SERVICE BULLETIN

34 NAVIGATION – KTR 2280 Multi-Mode Digital Radio (KTR 2280) – Software Modification 0203 to the KTR 2280, PN 069-01037-0102; Resolution Of the Precipitation Static (P-Static) Issue Causing Poor VHF Receiver Performance and the Nuisance MMDR 1/2 CAS Messages at Power On.

Revision 3, 19 Jan 2013

KTR 2280-34-06

Figure 41. External Label

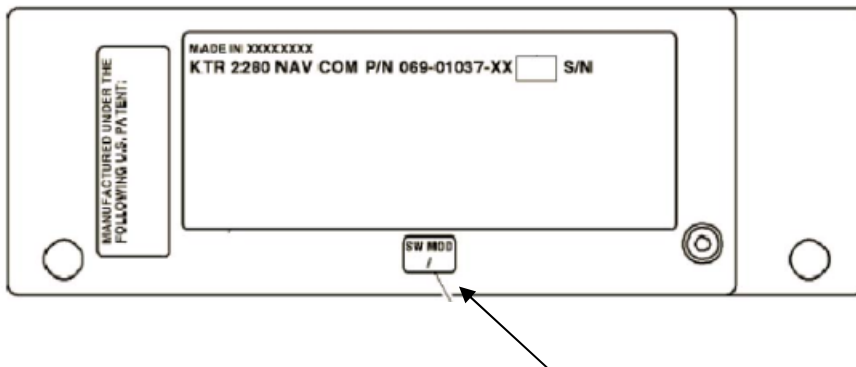
(1) Remove the SW MOD tag from the cover of the KTR 2280. Refer to Figure 41. Locate the new SW MOD tag, PN 057-05287-0203, and put it in the same location as the old tag.

Change SW Mod tag to HPN
